C. Design activities undertaken by individual identified in Section B. [Building Code Table 3.5.2.1 OF Division C]			
<input type="checkbox"/> House <input type="checkbox"/> Small Buildings <input type="checkbox"/> Large Buildings <input type="checkbox"/> Complex Buildings <input checked="" type="checkbox"/> HVAC – House <input type="checkbox"/> Building Services <input type="checkbox"/> Detection, Lighting and Power <input type="checkbox"/> Fire Protection <input type="checkbox"/> Building Structural <input type="checkbox"/> Plumbing – House <input type="checkbox"/> Plumbing – All Buildings <input type="checkbox"/> On-site Sewage Systems			
Description of designer's work HEAT LOSS / GAIN CALCULATIONS DUCT SIZING RESIDENTIAL MECHANICAL VENTILATION DESIGN SUMMARY RESIDENTIAL SYSTEM DESIGN per CSA-F280-12		Model: 2011 Project: CENTREFIELD (WEST GORMLEY)

SITE NAME: CENTREFIELD (WEST GORMLEY)										DATE: Apr-21		WINTER NATURAL AIR CHANGE RATE 0.236				HEAT LOSS ΔT °F. 78		CSA-F280-17					
BUILDER: ROYAL PINE HOMES										TYPE: 2011		GFA: 1792		LO# 87544		SUMMER NATURAL AIR CHANGE RATE 0.071				HEAT GAIN ΔT °F. 13		SB-12 PERFORMANCE	
ROOM USE				MBR		ENS		BED-2		BED-3				BATH

BASEMENT PLAN, EL. 'A' & 'B'

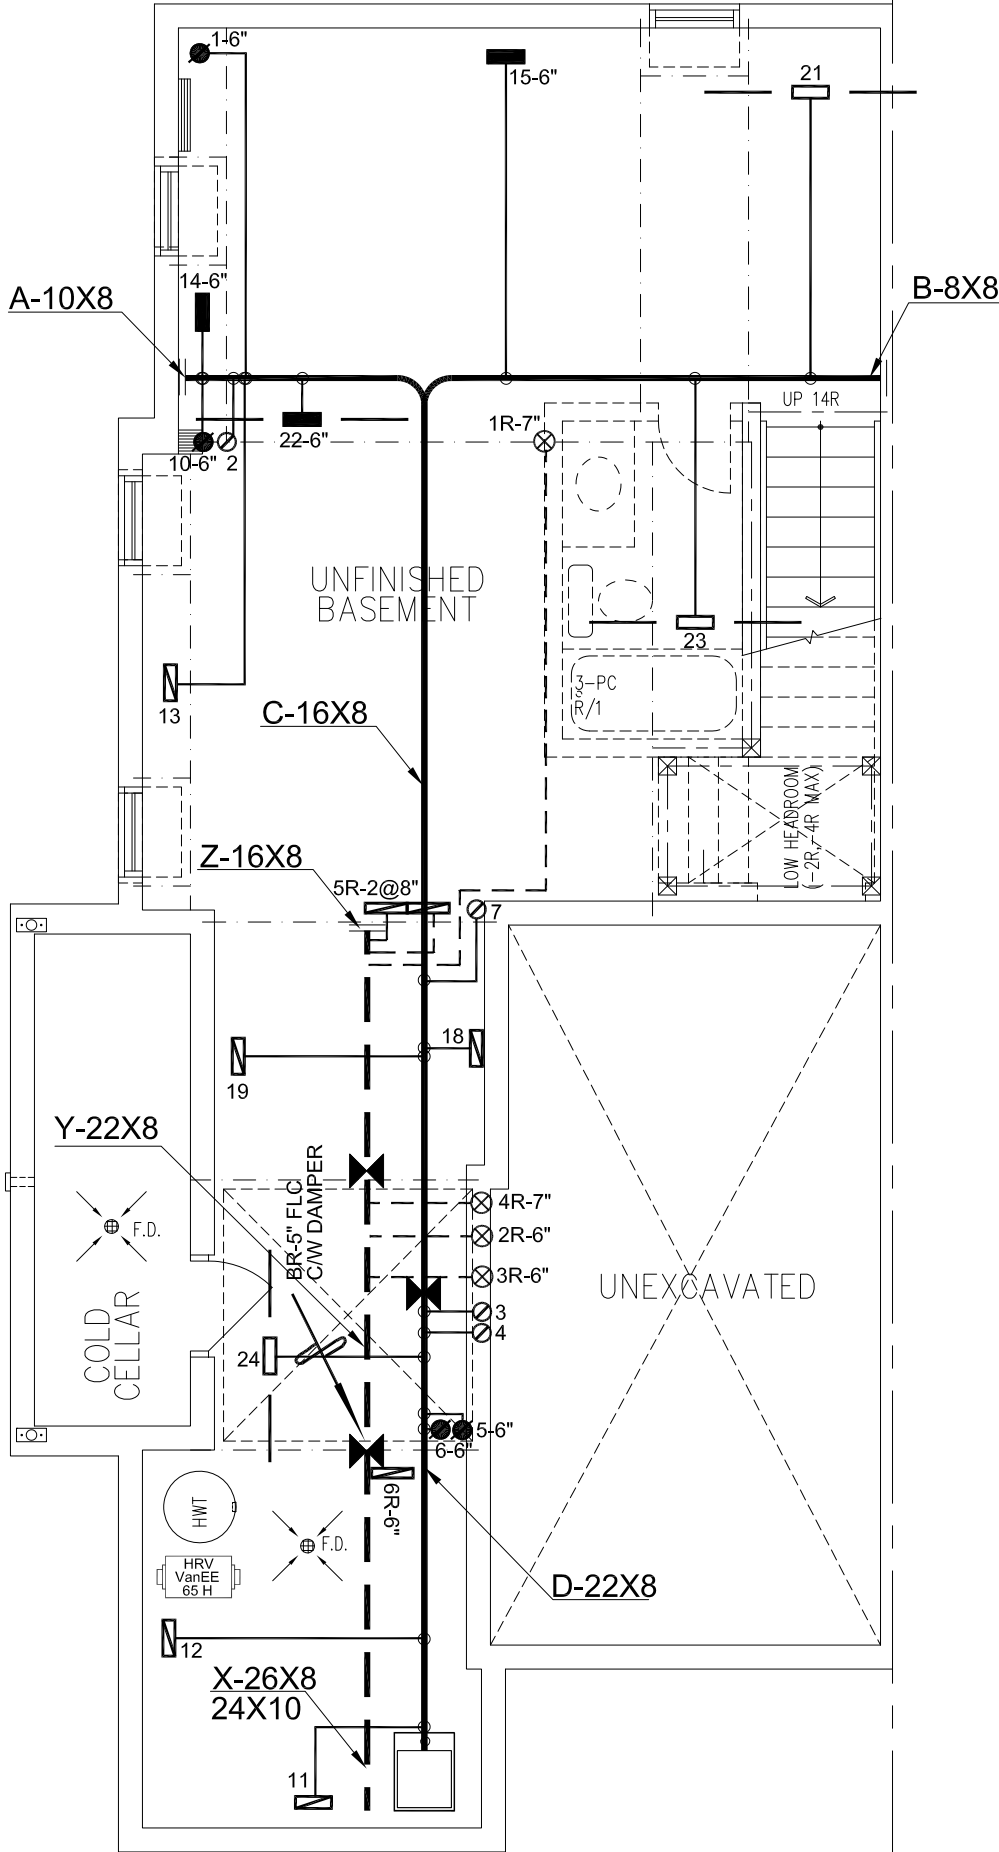
Ensure that R-Values and U-Values used for heat loss and heat gain calculations are consistent with the values specified by SB-12 Performance Compliance: Energy Modeling/air leak test and the values used for architectural design.

Minimum R-12 Insulation Value required for ducts installed at unheated or exposed condition (OBC 2012 Div.B 6.2.4.3(10) and seal the ducts as per 6.2.4.3(11) & HRAI Digest 2005, Clause 4.5.

Penetration of Air Barrier System by ducts, wires, conduits or building materials shall be sealed as per OBC 2012, Div.B 9.25.3.3.(9) & (10).

HRV Unit shall be energy qualified complete with sealed and insulated connection to outdoor vent hoods per Energy Star Technical Specification 4.7.1.2. When HRV is used as principal fan, the controller shall be wired to the HRV Unit and interconnected to the furnace fan. HRV shall be designed for operation at outside temperature of -25°C and a flow of minimum 30 L/s (64 CFM)

Volume control dampers to all branches to be installed per OBC 2012, Div.B, 6.2.4.5.

Space between studs and joists used as return ducts shall be separated from unused portion as per OBC 2012 Div.B 6.2.4.7(6)

Combustion air supply shall be provided to the furnace and hot water tank.

HRV installation, testing, startup and commissioning shall be in compliance with OBC 2012, Div.B 9.32.3.11, 9.32.3.11(7)&(10)

HRV duct connection shall be in compliance with OBC 2012 Div.B 9.32.3.6(3) & 9.32.3.4(7).

Supply air grill at finished basement shall be at low level. Return air grill for finished or unfinished basement shall be at low level. HRAI digest 2005, clause 7.7(3).

Air supply outlet shall not be installed on a furnace plenum or trunk duct. (HRAI Digest 2005, 4.6)

Exterior insulation effective R-Value for wall, roof or exposed floor shall be maintained at the respective location where duct or sanitary pipes are routed inside exterior envelope.

Return air intake shall be provided as recommended in HRAI Digest 2005 Section 4.7 Return air inlet should be positioned so that short circuiting of supply air is avoided. A high and low wall return air combination shall be provided when a combined cooling & heating system is installed.

For simplified HRV/ERV installation, with stale air and fresh air connected to return air plenum, stale air intake and fresh air supply shall be separated minimum 3' or as recommended by HRV/ERV Manufacturer.

GROUND FLOOR PLAN, EL. 'A'

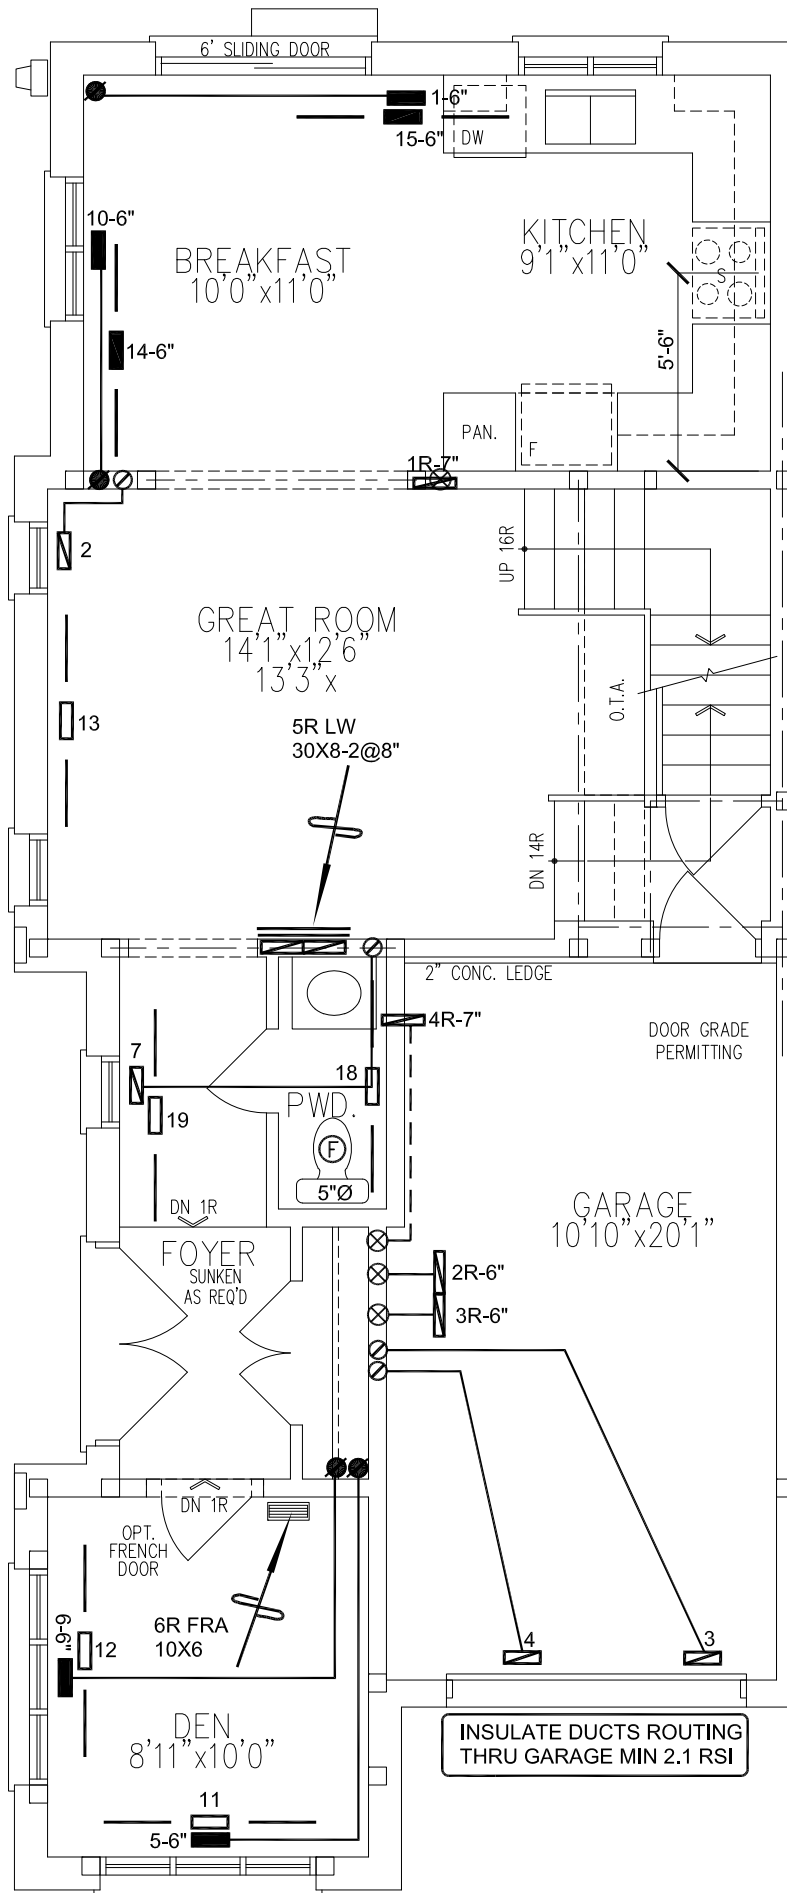
Space between studs and joists used as return ducts shall be separated from unused portion as per OBC 2012 Div.B 6.2.4.7(6)

Kitchen hood exhaust duct shall be provided as per OBC 2012, Div.B 9.32.3.10, 9.32.3.5(2).

Exterior insulation effective R-Value for wall, roof or exposed floor shall be maintained at the respective location where duct or sanitary pipes are routed inside exterior envelope.

SECOND FLOOR PLAN, EL. 'A'

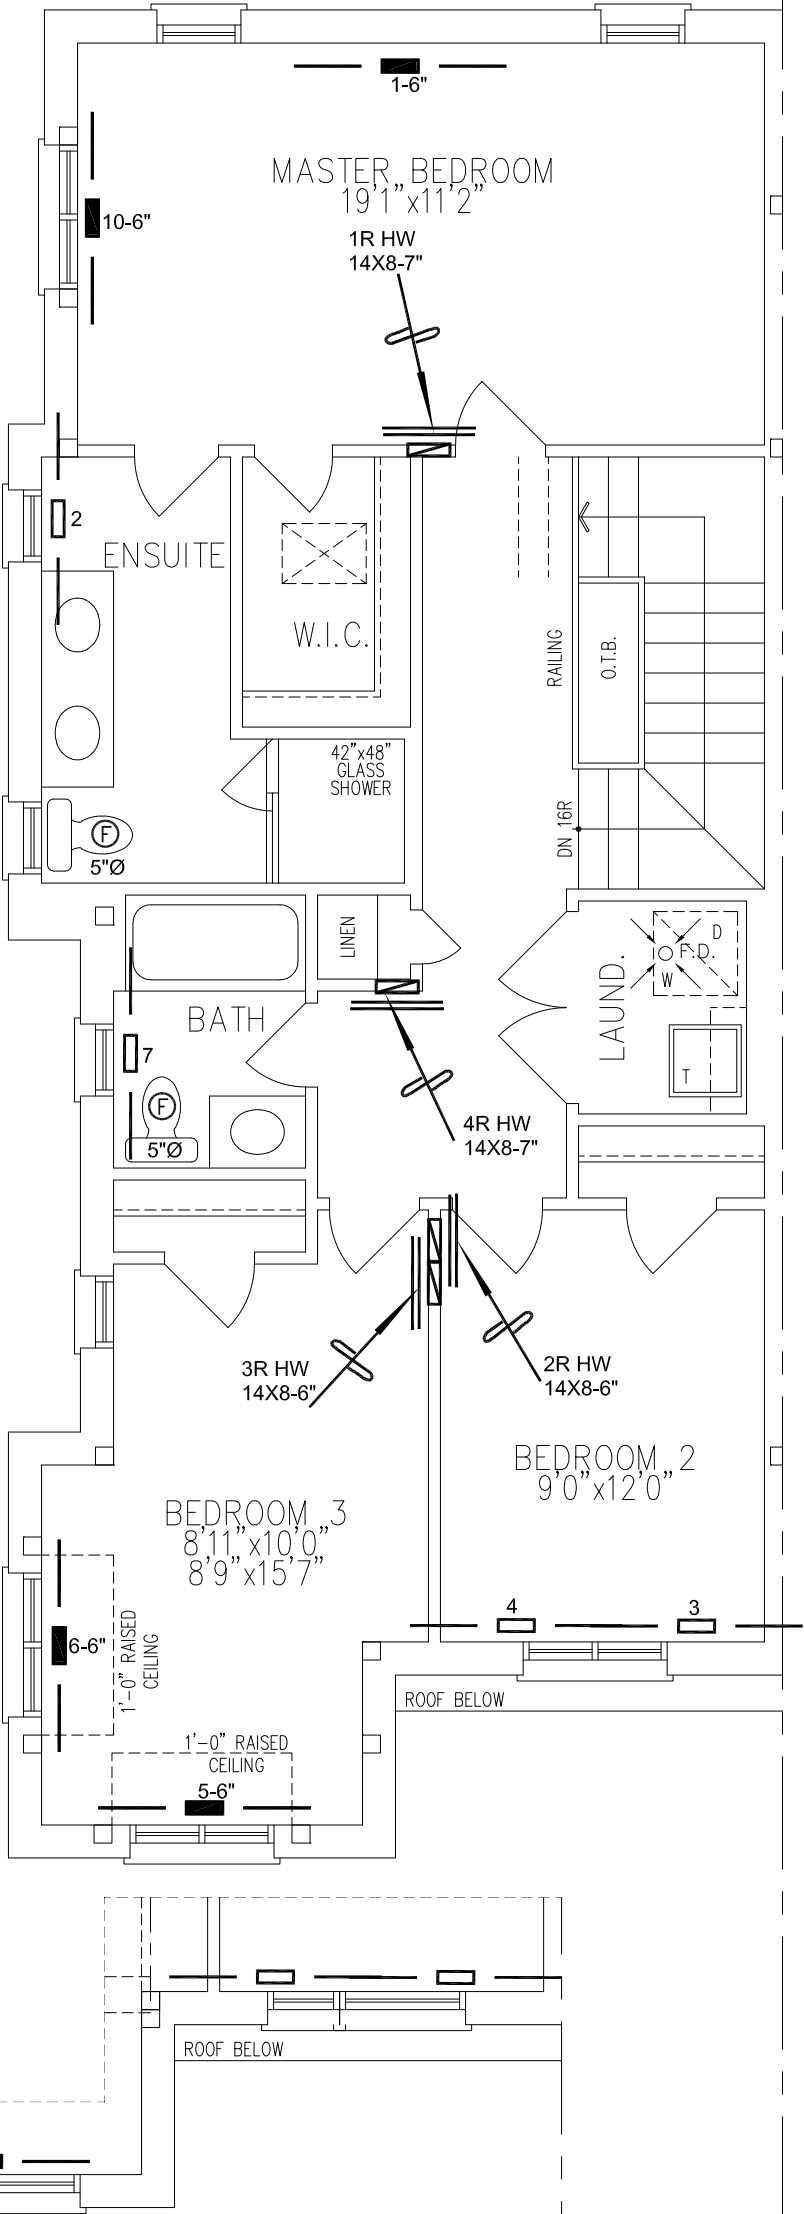
Space between studs and joists used as return ducts shall be separated from unused portion as per OBC 2012 Div.B 6.2.4.7(6)

Laundry dryer exhaust duct shall be provided as per OBC 2012 Div.B 6.2.3.8(7).
